ADDENDUM NUMBER TWO
for the
Alarcon Street Improvements Project

DATE OF ADDENDUM: October 11, 2016

Alarcon Street Improvements Project CIP16-008

DEMOLITION PLAN (3 OF 3)

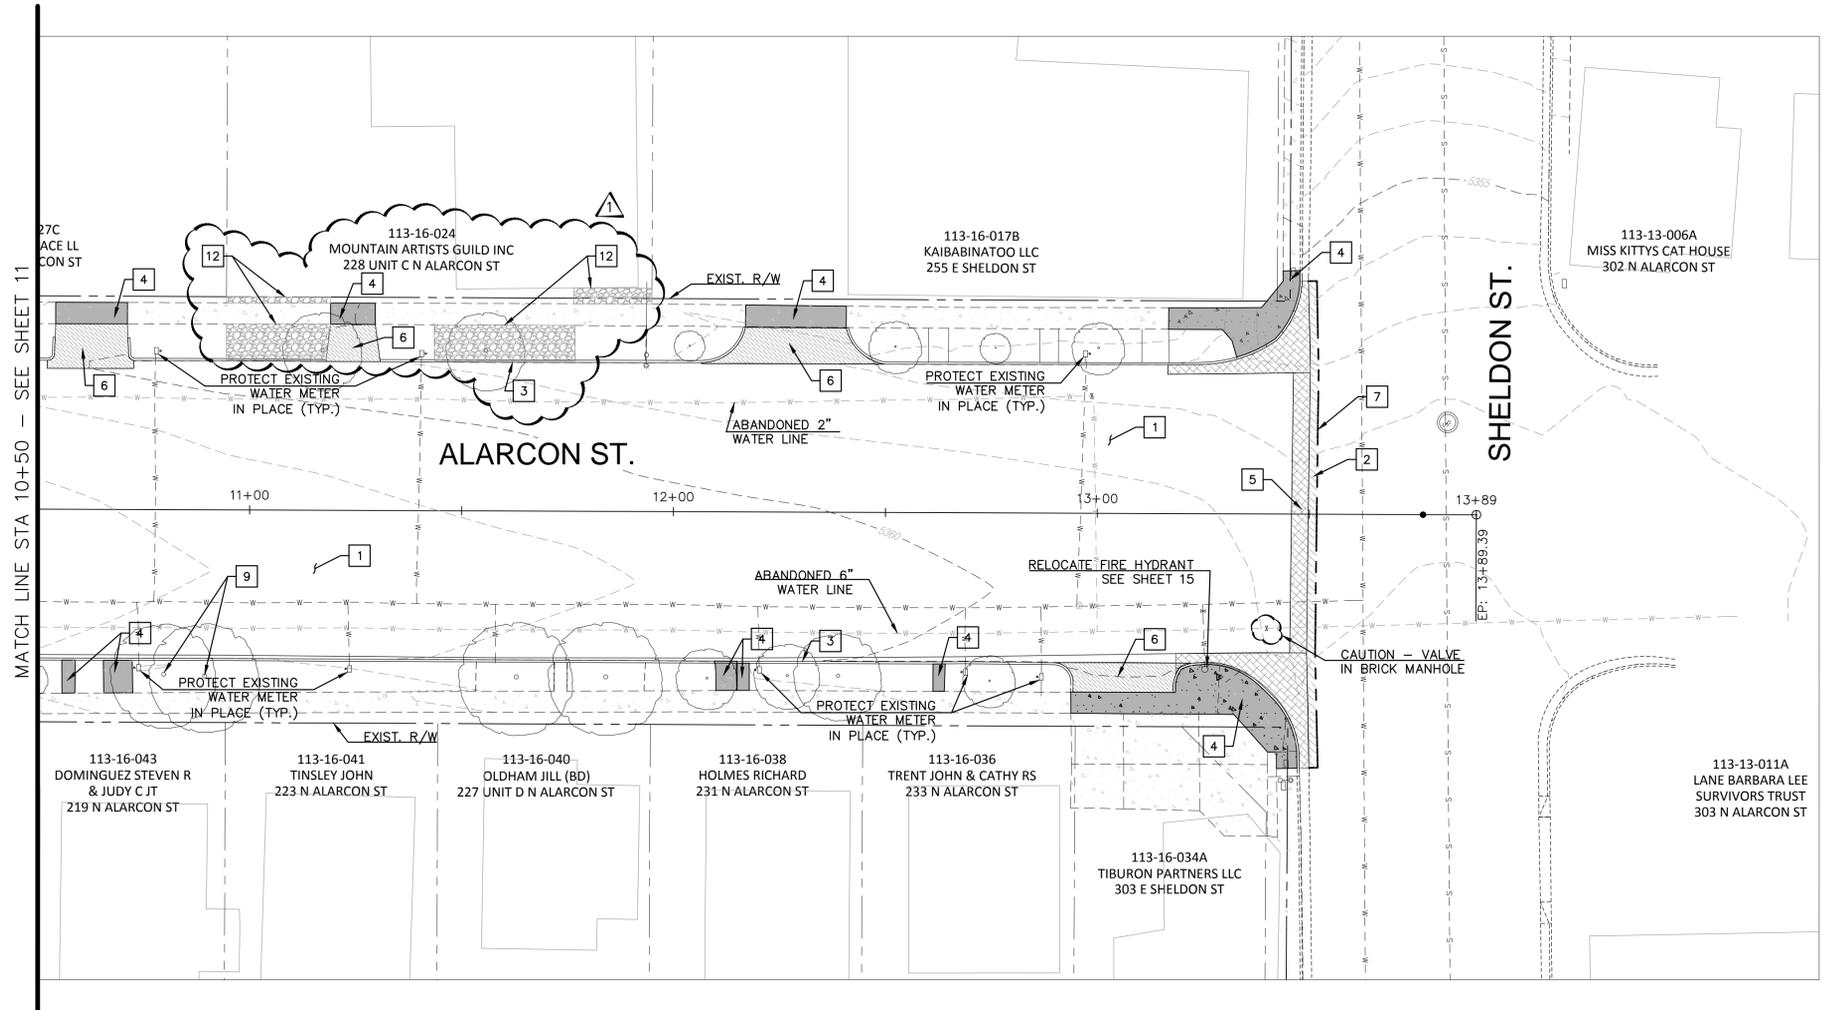
LOCATED RIVER ROCK TO BE REMOVED

ALARCON STREET ROADWAY
PLAN STA 1+00 - 5+50

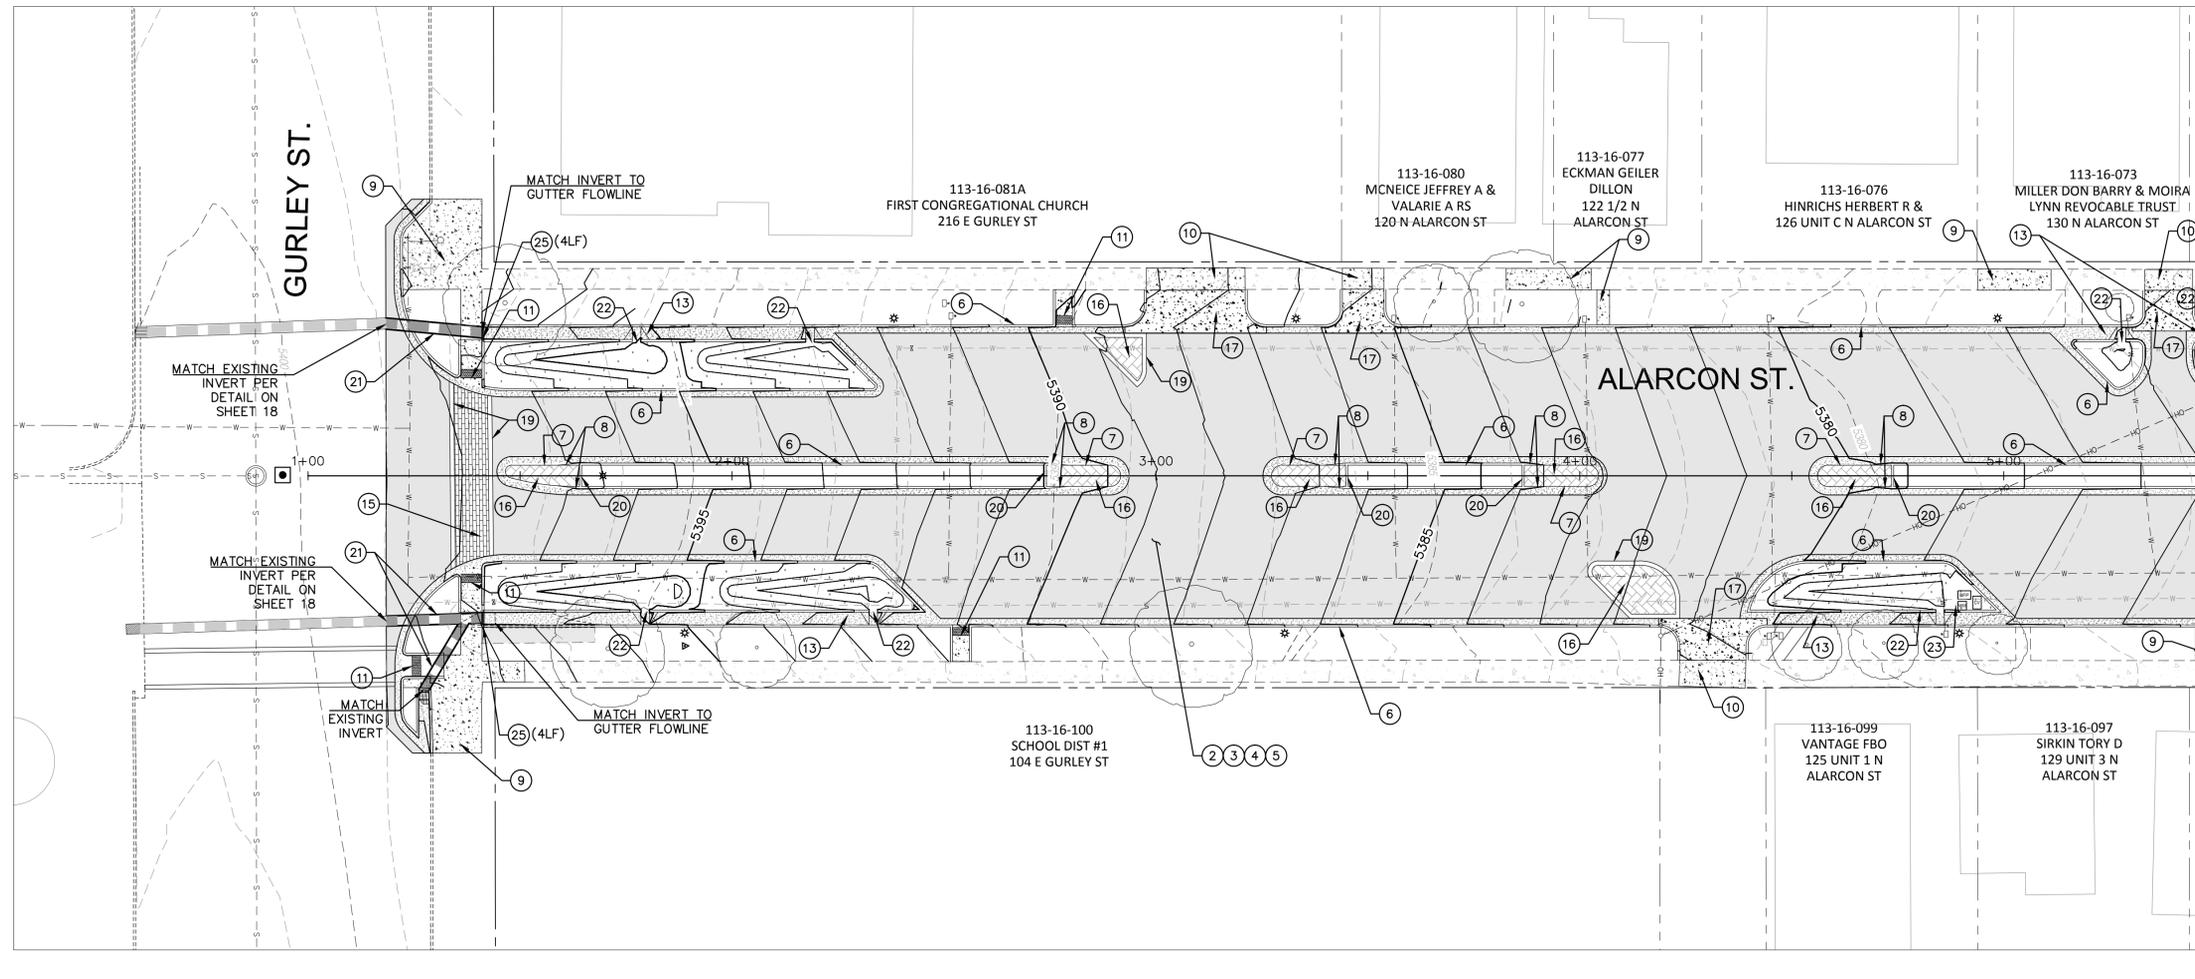
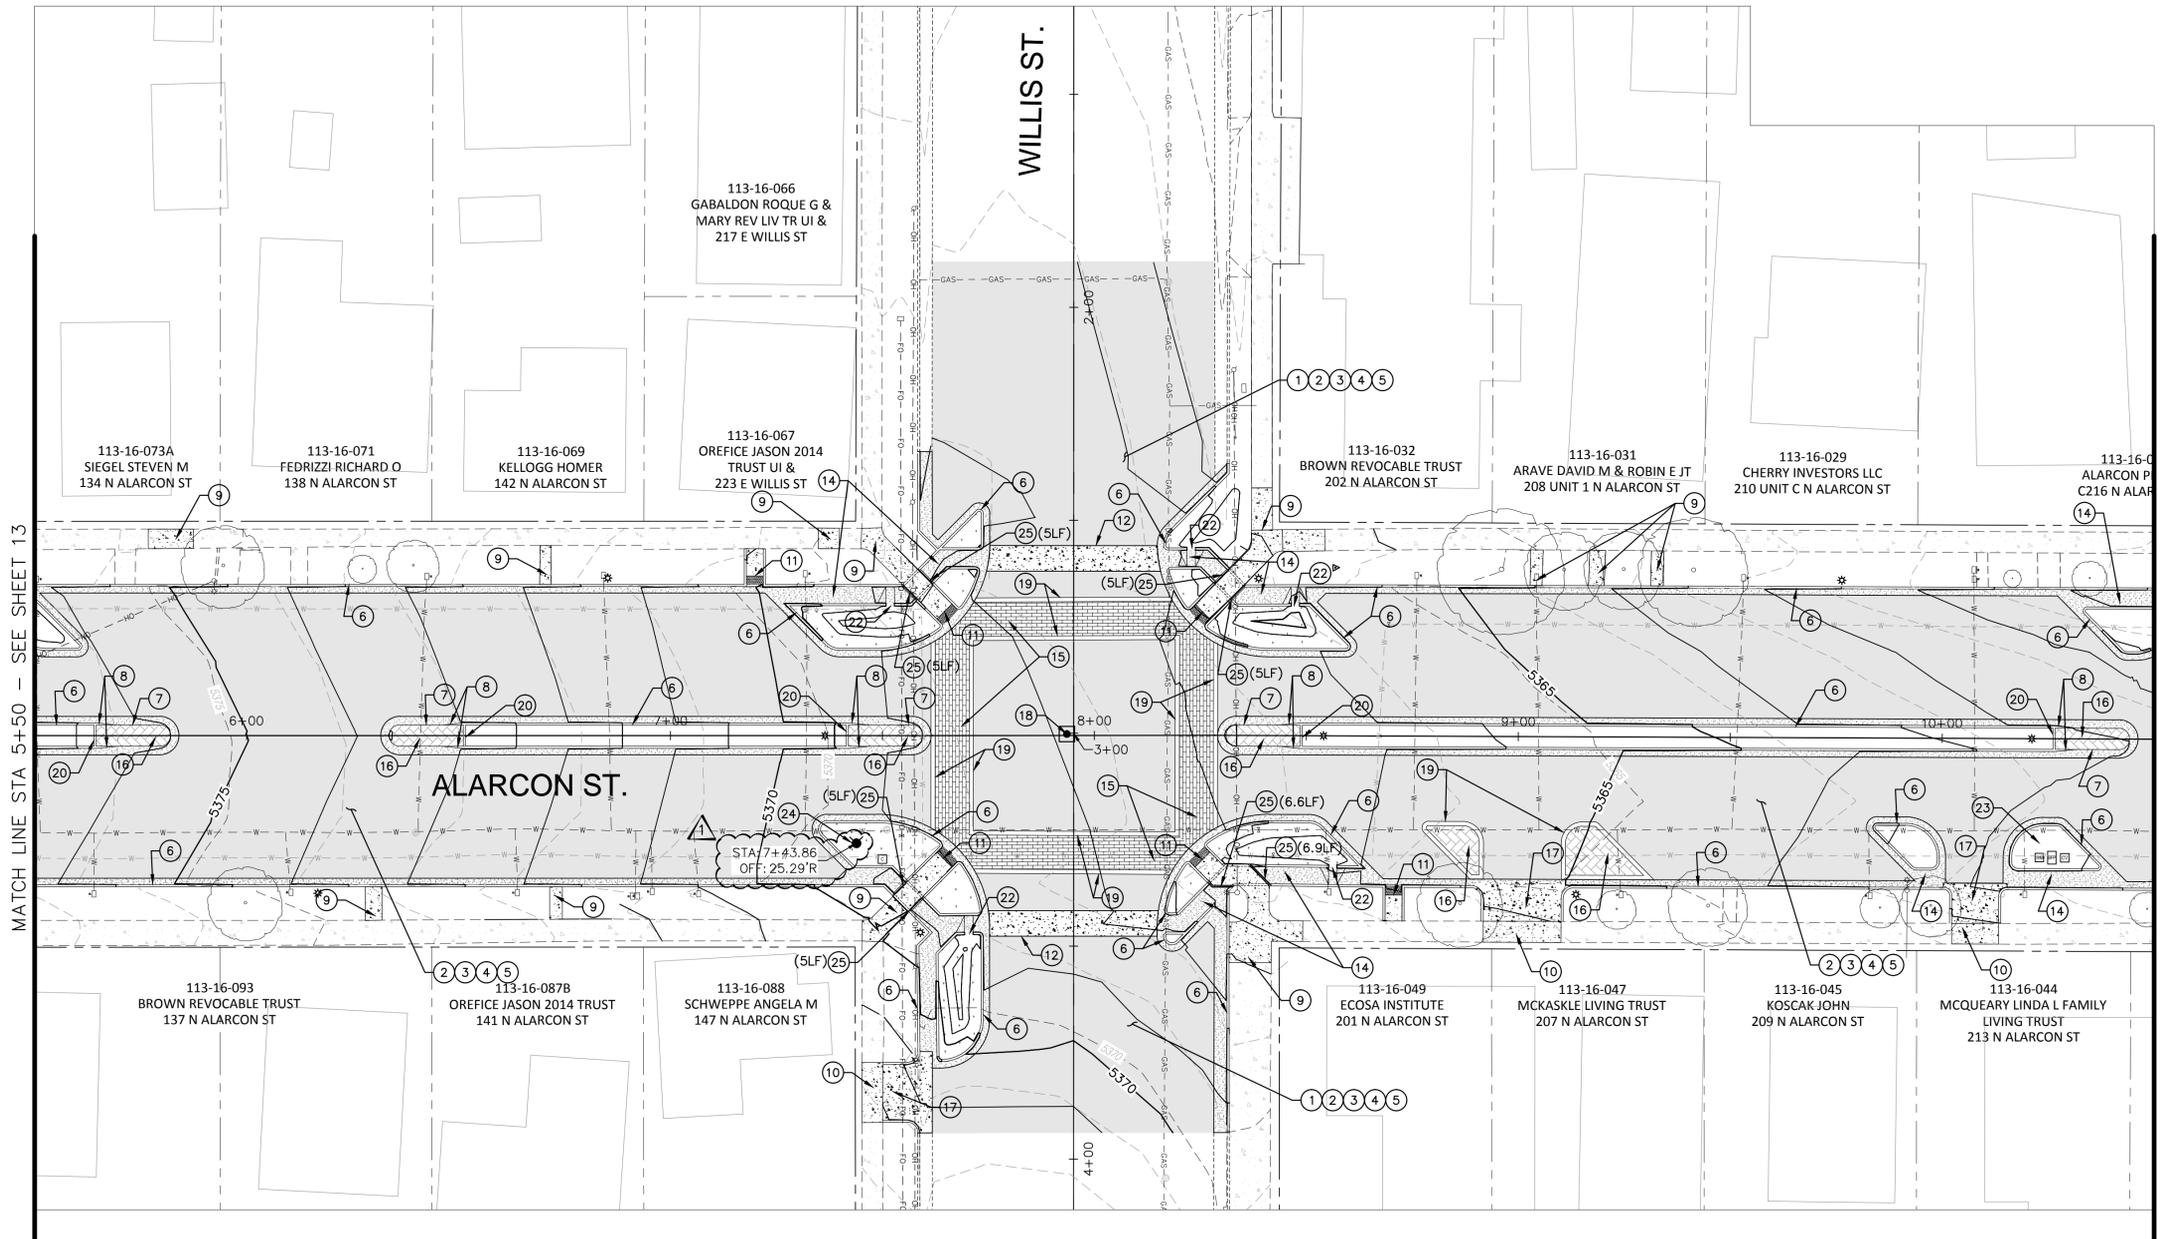
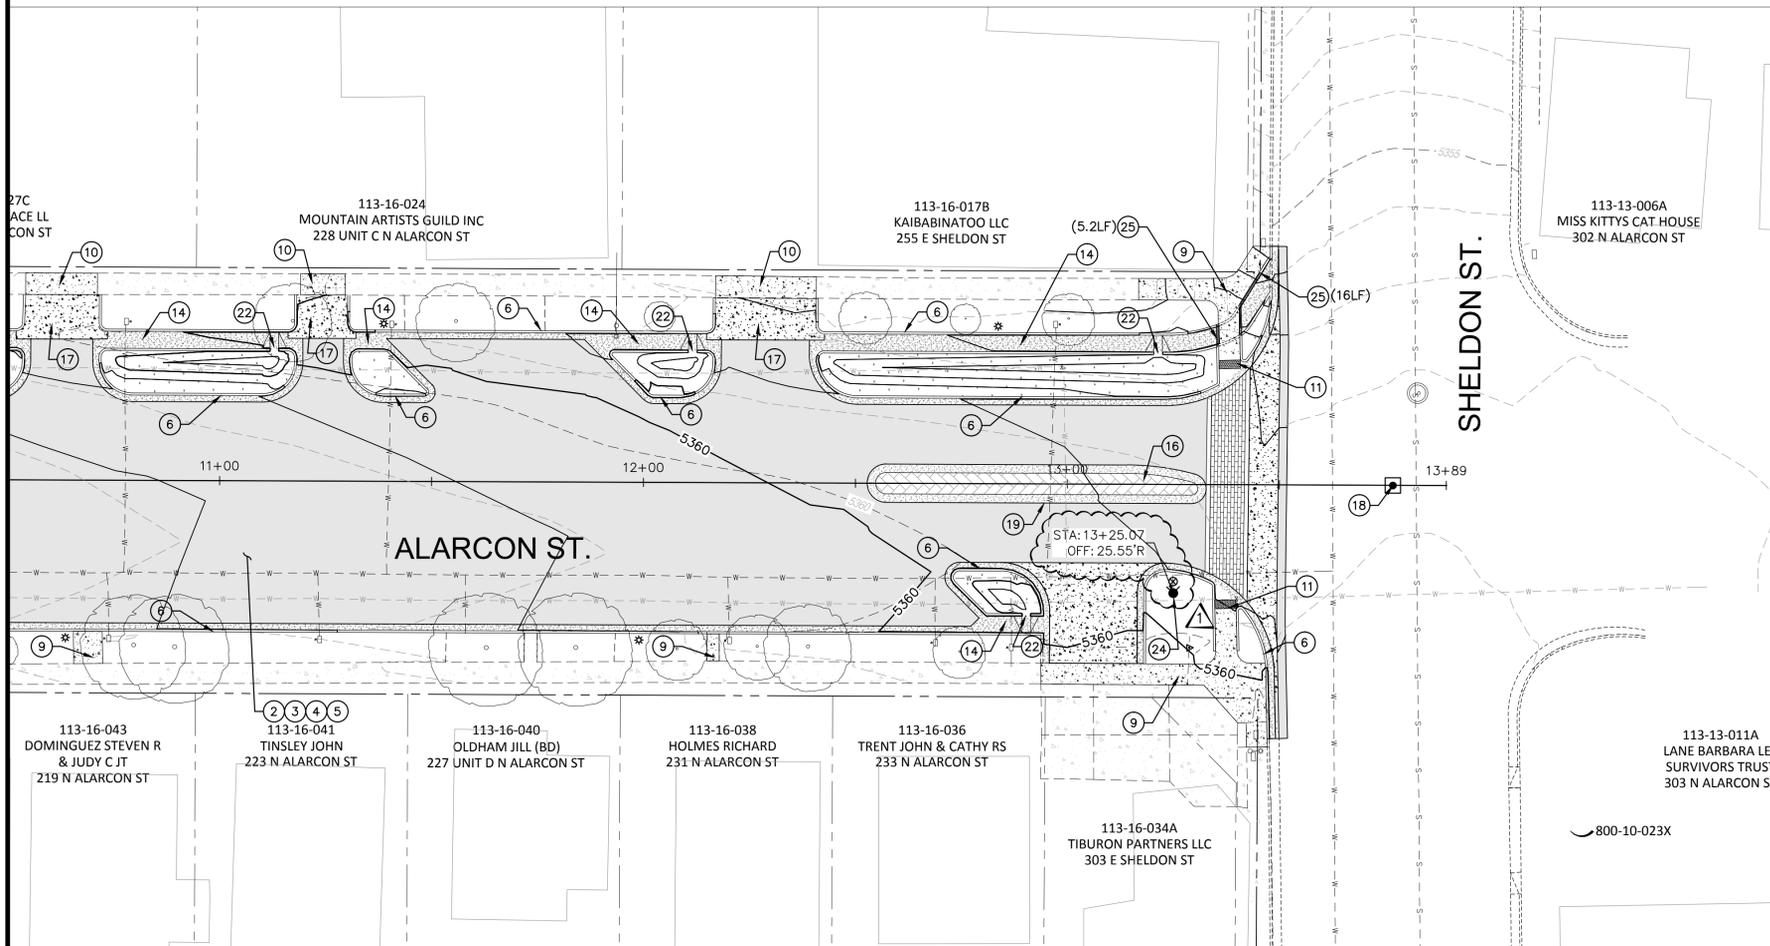
B: Where is the relocation of the fire hydrants going to be? The plans don't show the existing locations and where they will be moved.

D: Are there any details for the shallow box culvert? Does it have a lid? What is the thickness of the base?

Response: The relocation of the fire hydrants is now shown on sheets 13-15 of the plans provided with this addendum.

Response: Details for the shallow box culvert are now shown on sheets 13-15 of the plans provided with this addendum.

ADDED STATION AND OFFSET TO NEW FIREHYDRANT LOCATION

COP STANDARD DETAIL 1" - 2" WATER SERVICE CONNECTIONS REVISED: 07/16 DETAIL No. 316P

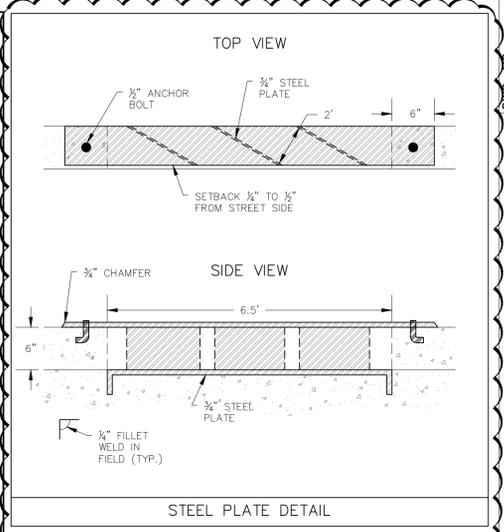
V: Going back to the water meter box at 316P, there is a detail past that meter box that shows a customer shut off valve and PRV with a #1 box. Is that going to be included?

Response: Per Detail 316P, the box on the customer side is required.
